Amendment # 2

Approved Building Consent Document

TODD RESIDENCES - 53 EDWARD AVENUE - CHRISTCHURCH

LOWER SERVICES PLAN 1:50

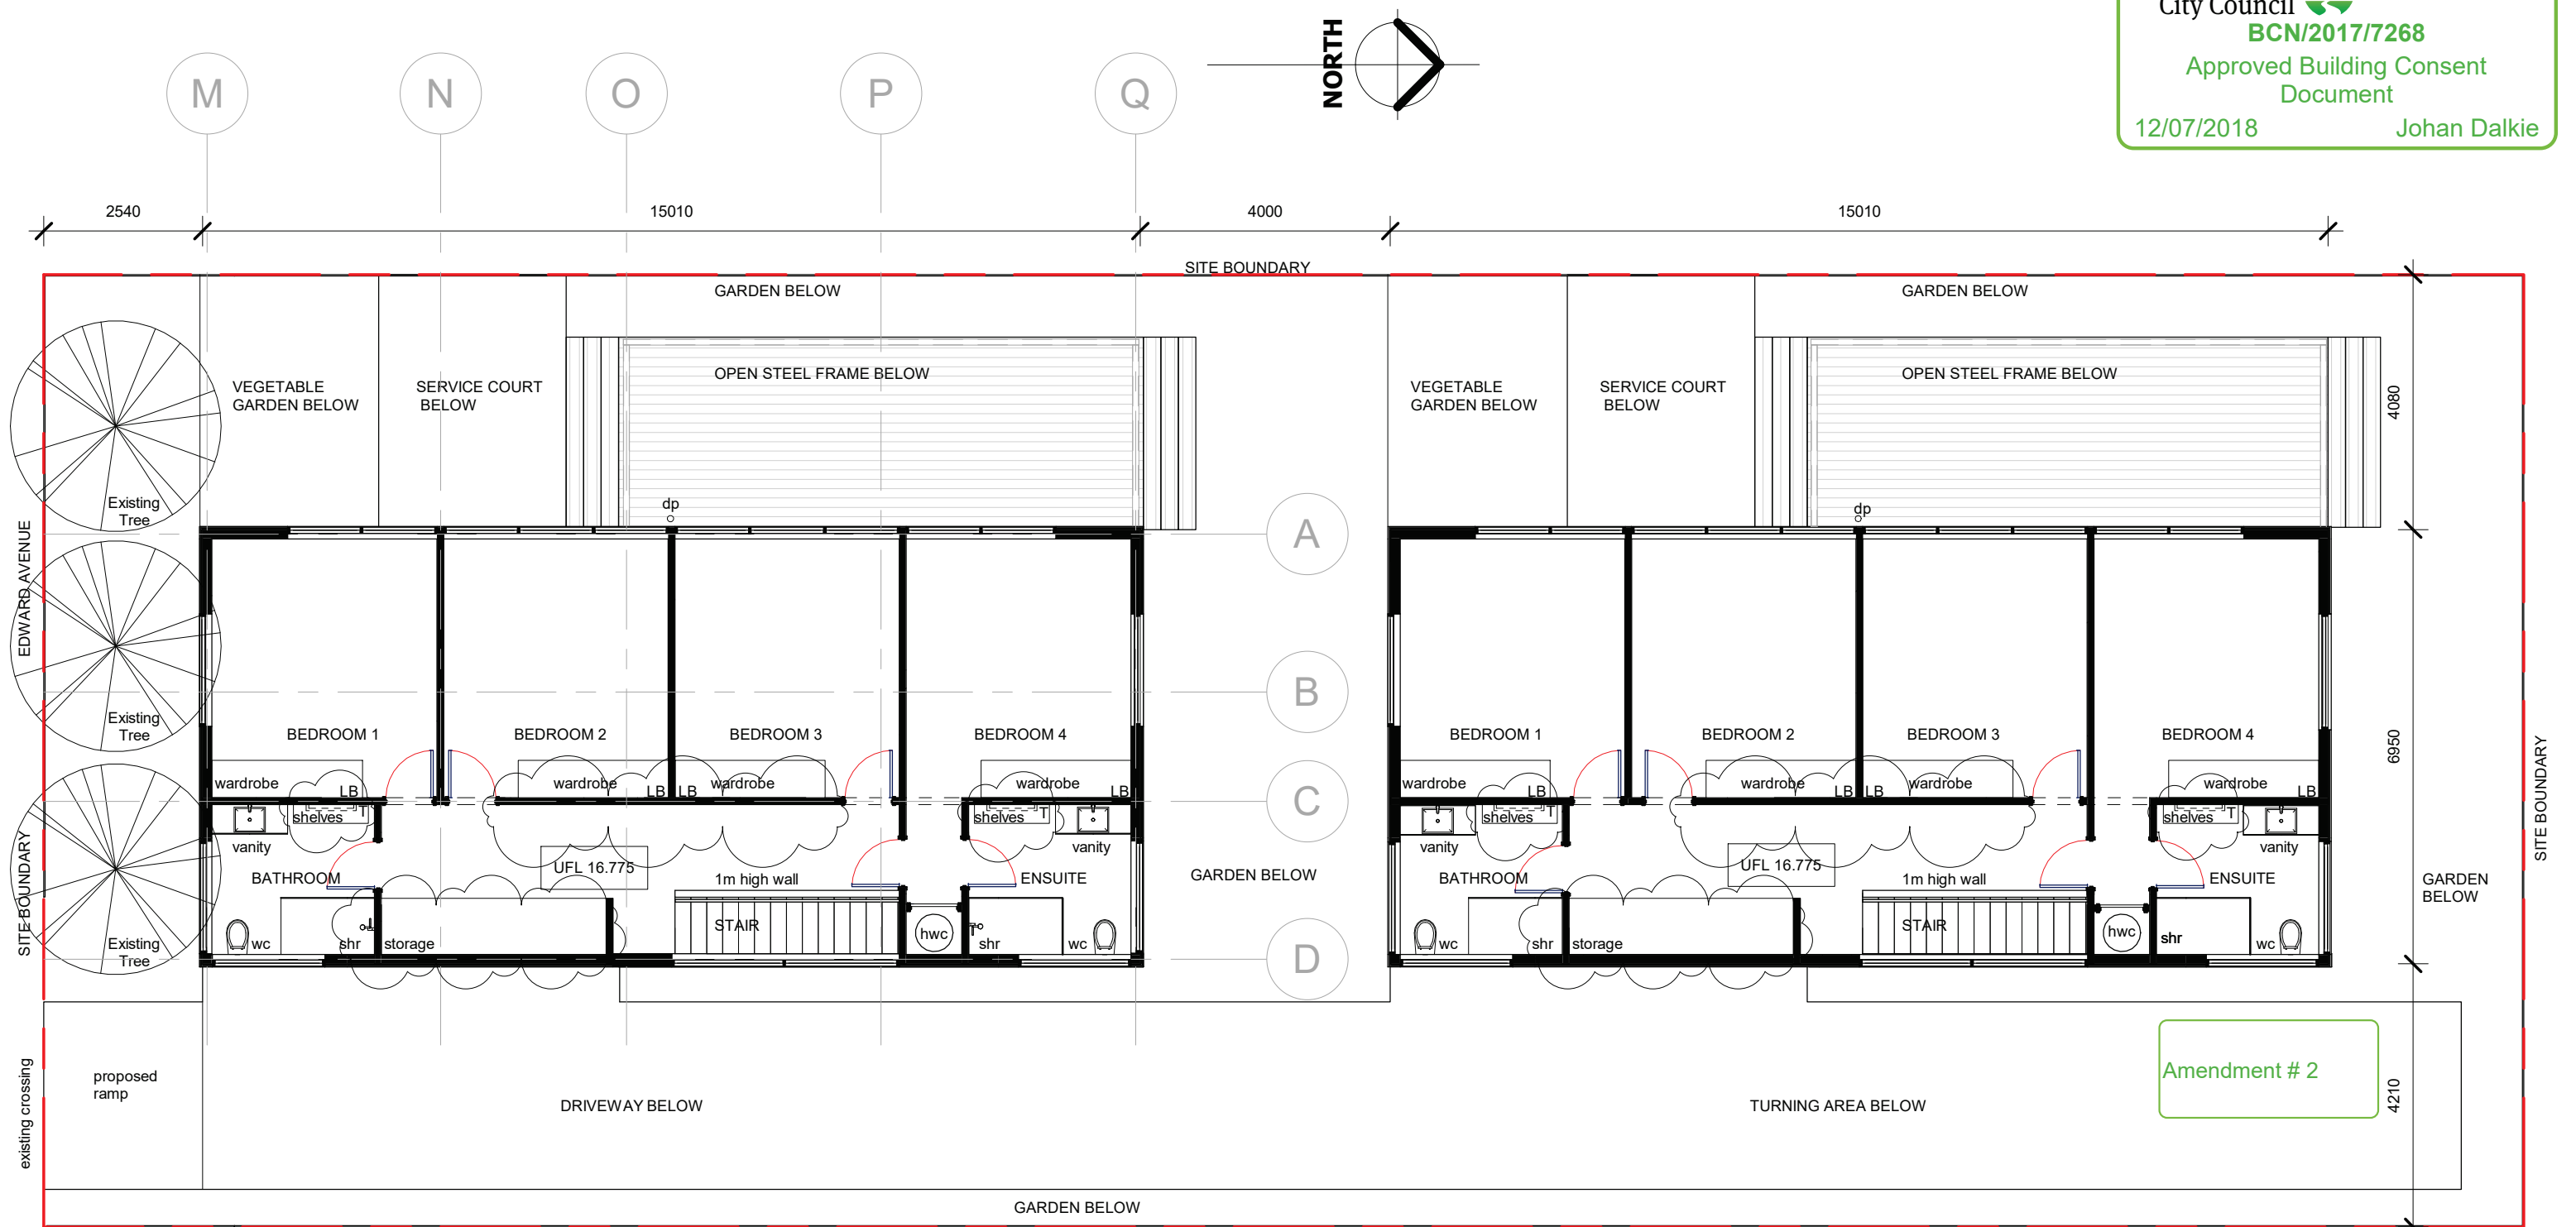
Amendment A - 6/11/17
Entrance porch and steps removed. Front entry door changed to glazed full height window. Plywood soffits have been replaced by Innwood Soffits. Sill by owner within steel frame added to Deck / Outdoor area. Heatpump changed to a ceiling cassette unit.

Amendment B - 03/04/18
Front entry glazed full height window reduced to 600 wide. Sliding stacker doors changed to 2 sliders over 2 fixed panels. Kitchen location adjusted. Kitchen switch and lighting in Kitchen adjusted. Carpet square added.

Amendment C - 30/04/18
Laundry wall shortened. PV panel batteries and automation equipment located under the stair.

Amendment D - 30/05/18
Electrical legend updated. Sensor location moved. Dimmer added to LED strip lights. LED channel 140 adjusted and dimensioned. Heatpump, Carpet square and Kitchen Island location adjusted.

Amendment E - 17/06/18
PV panel batteries and automation equipment moved to Upper Level. Laundry sliding door replaced with bi-fold doors. Heat pump location moved to stair wall.

UPPER SERVICES PLAN
1:50

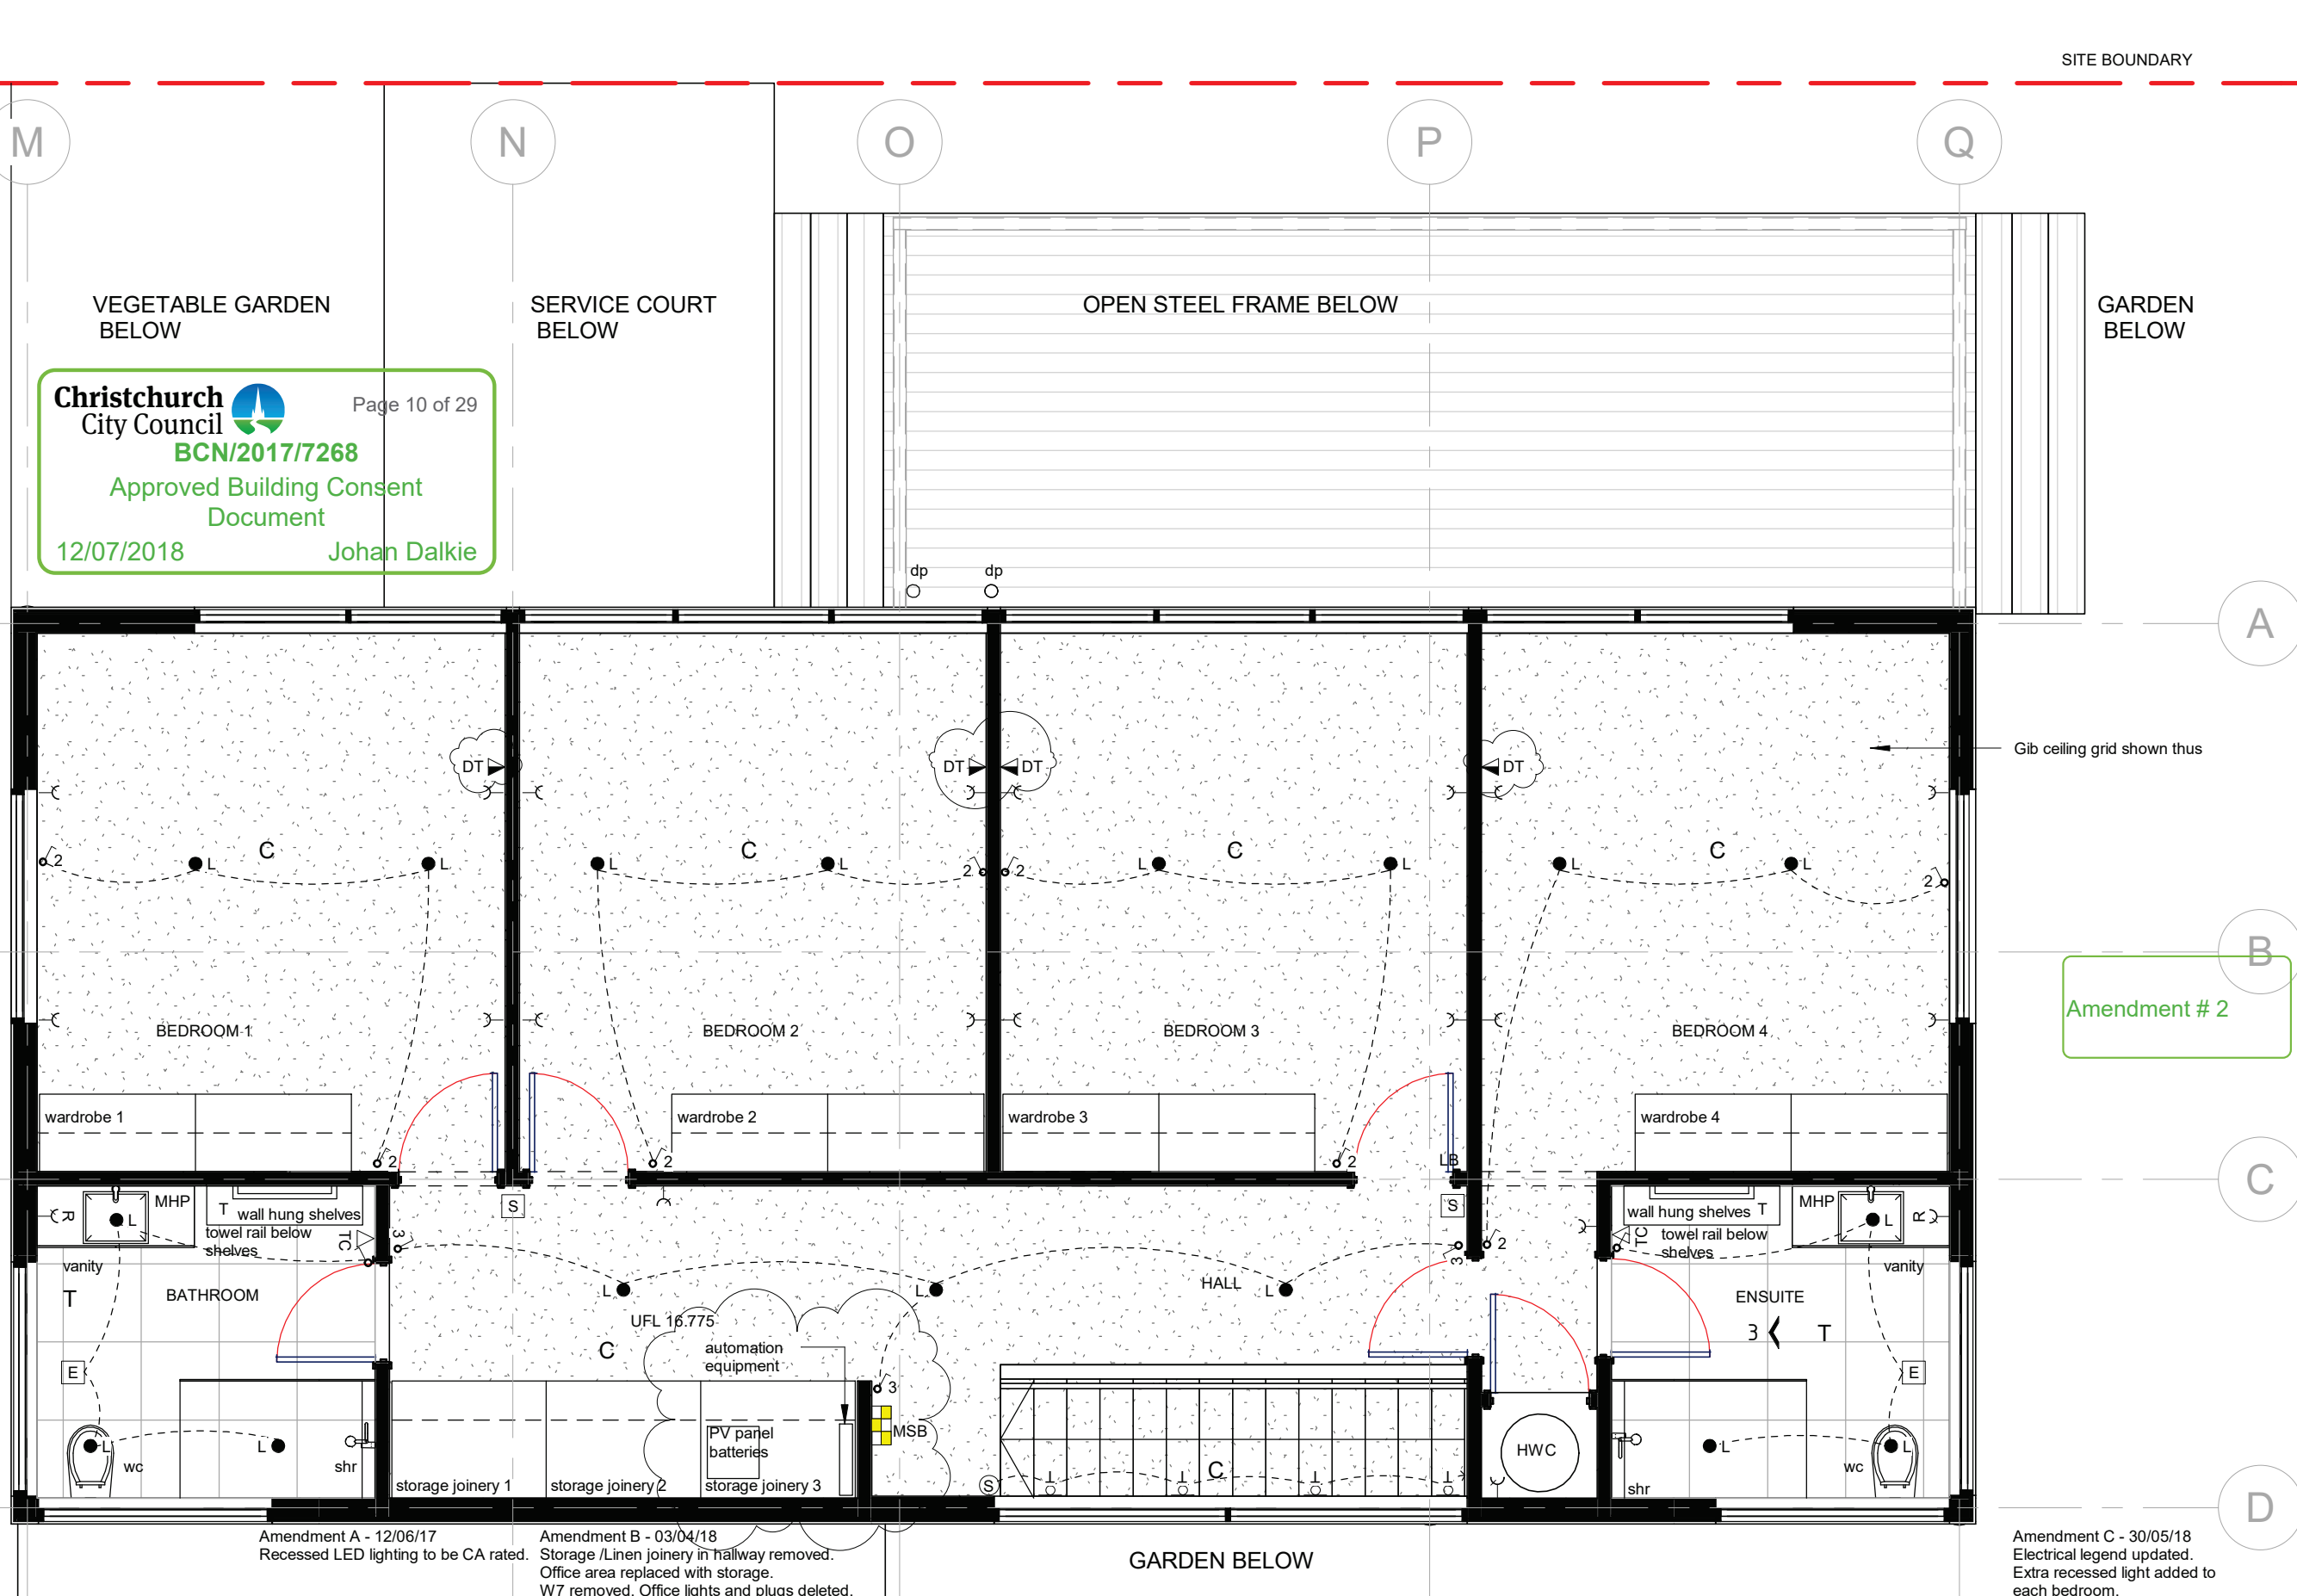
Amendment A - 12/06/17
Recessed LED lighting to be CA rated.

Amendment B - 03/04/18
Storage /Linen joinery in hallway removed.
Office area replaced with storage.
W7 removed. Office lights and plugs deleted.
Data and TV in each bedroom deleted.
2 extra plugs added to each bedroom.
Joinery unit in Bathroom and Ensuite replaced with shelves. Wardrobes updated.
Towel rail moved. MSB moved to top of stair.

Amendment C - 30/05/18
Electrical legend updated.
Extra recessed light added to each bedroom.
Amendment D - 17/06/18
Data outlet added to each bedroom.
PV panel batteries and automation equipment relocated to upper level storage joinery.

SECTION A-A

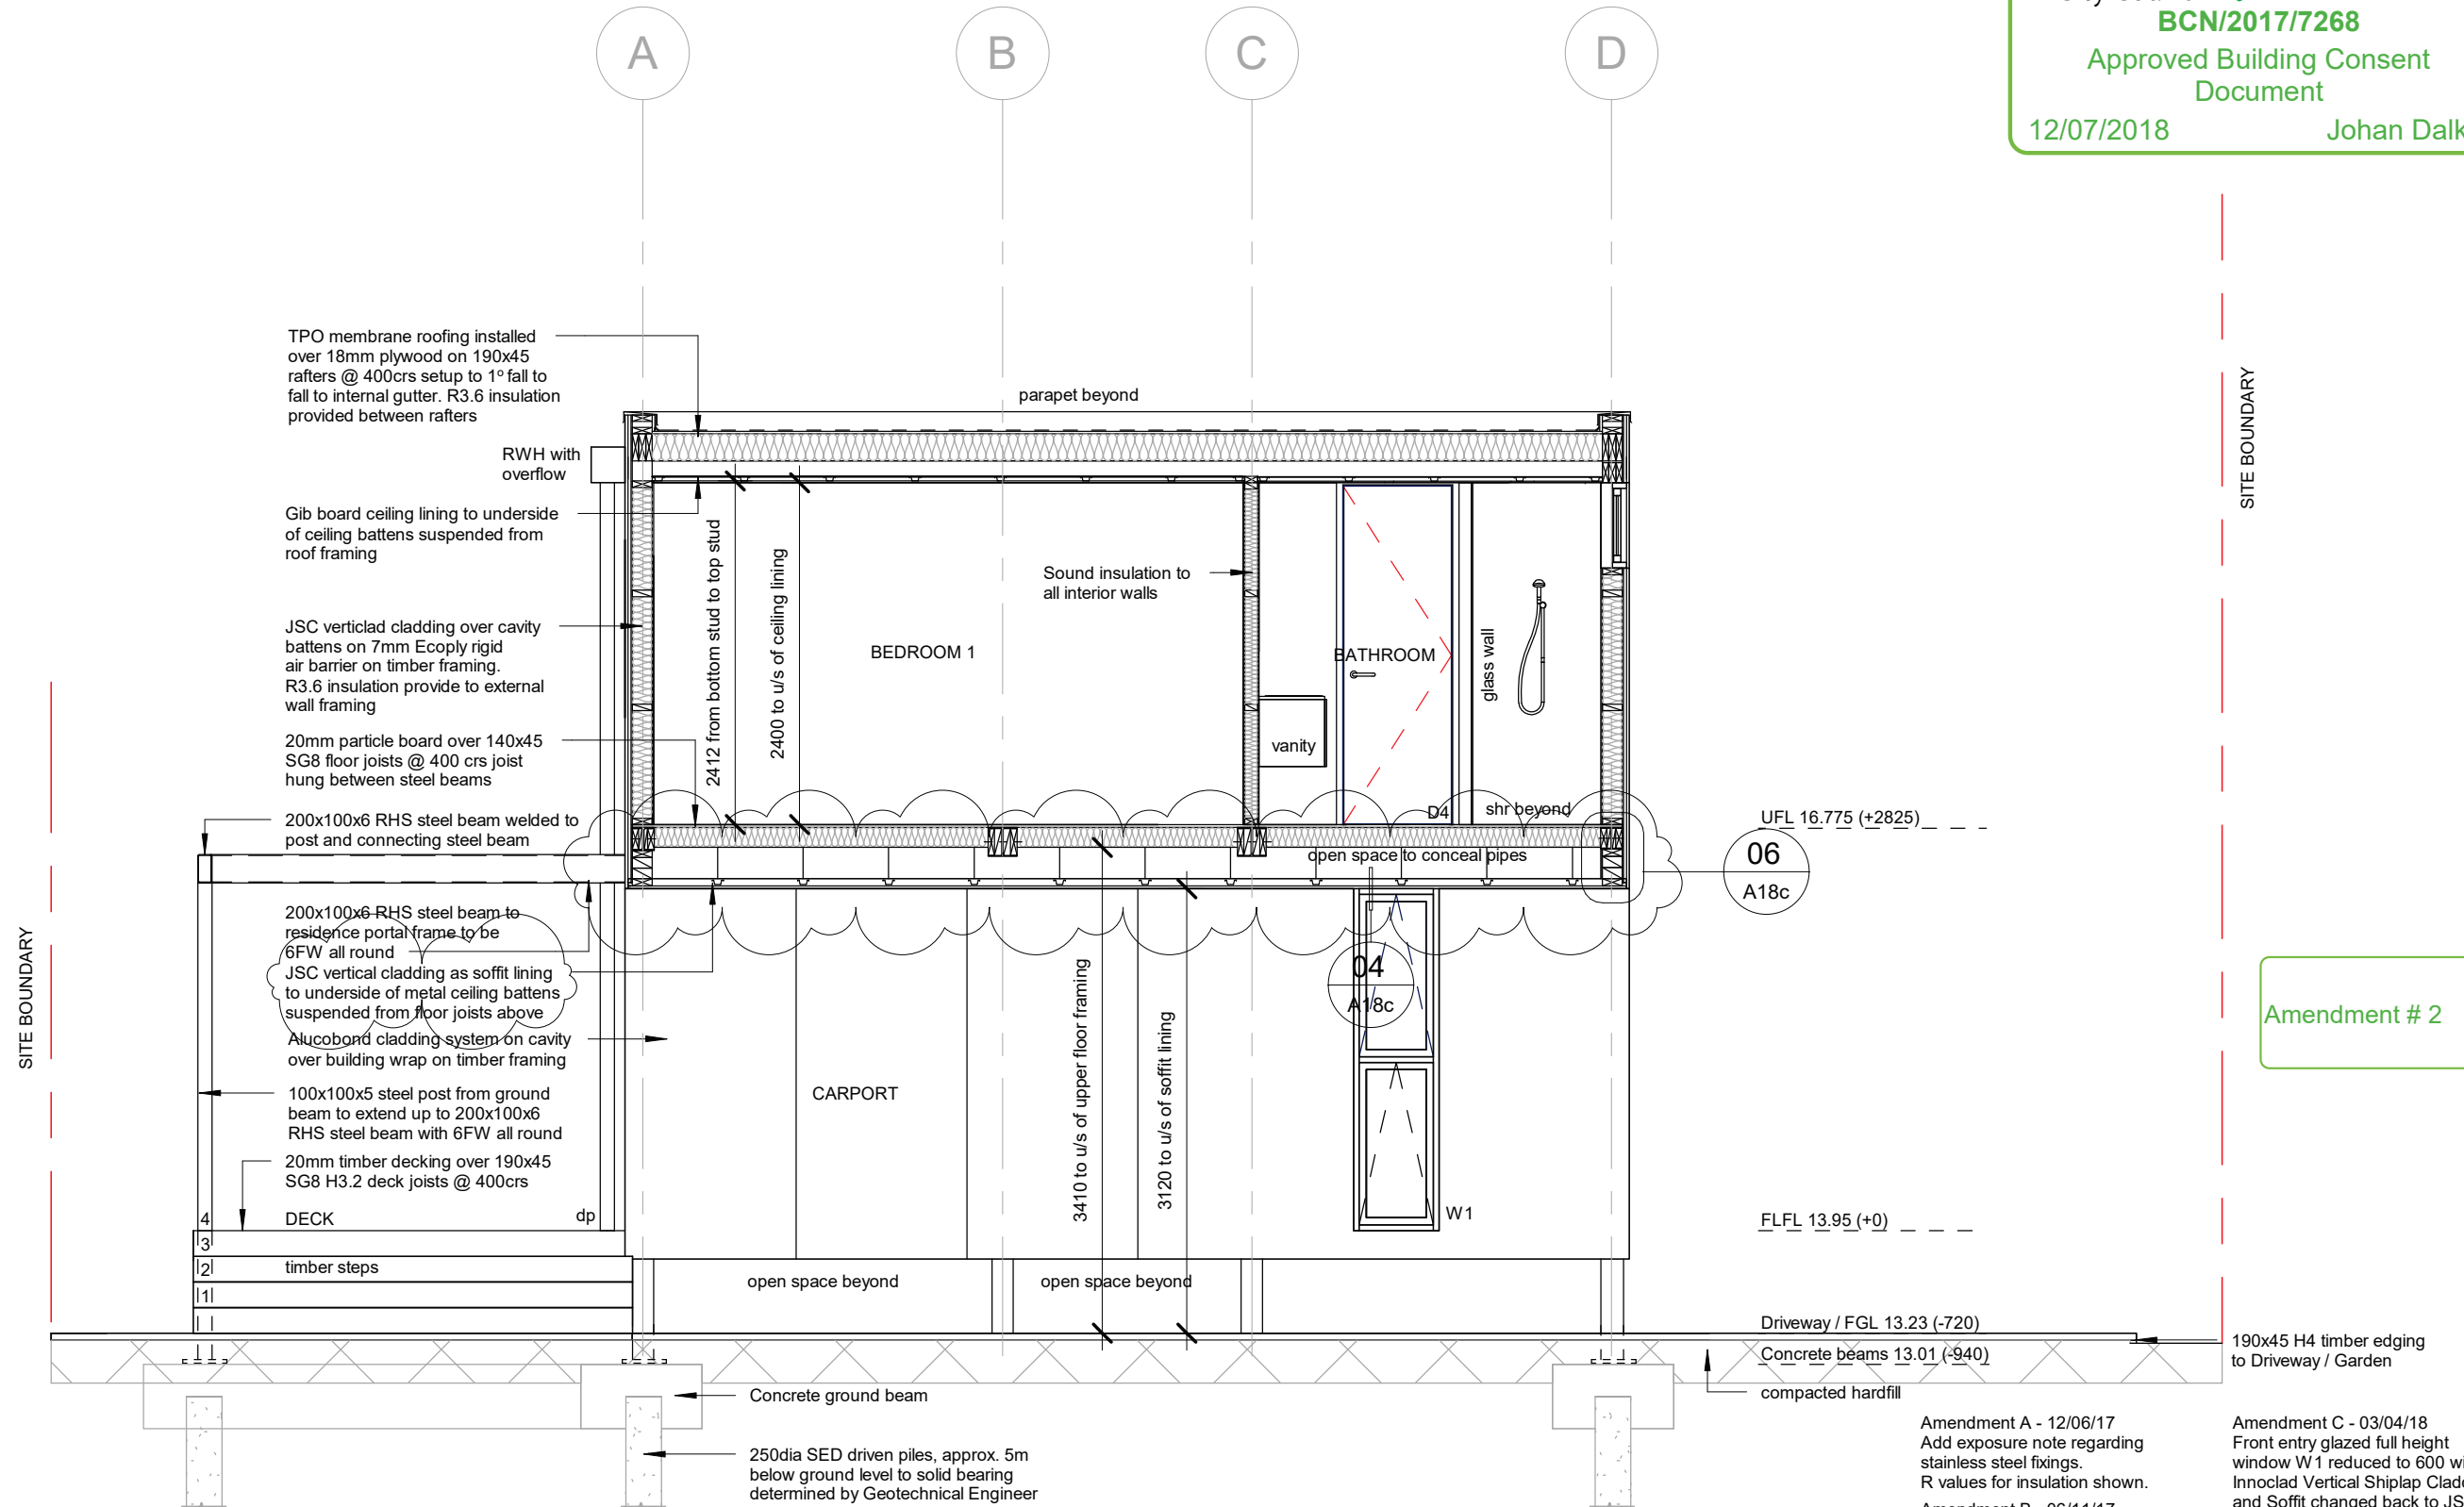
Amendment A - 06/11/17
JSC Vertical Cedar Cladding changed to Innoclad Vertical Shiplap Cladding. Plywood soffits have been replaced by Innoclad Soffit. Entrance porch and steps removed. Front entry door changed to glazed full height window. Sill by owner within steel frame added to Deck / Outdoor area.

Amendment B - 03/04/18
Front entry glazed full height window reduced to 600 wide. Sliding stacker doors changed to 2 sliders over 2 fixed panels. W7 deleted. Wall Cladding 2 and Soffit changed back to JSC cedar verticlad cladding.

Amendment C - 30/04/18
Soffit construction changed back to JSC cedar verticlad cladding fixed to metal ceiling battens hang from timber joists.

Amendment D - 30/05/18
Windows width reduced on lower level.
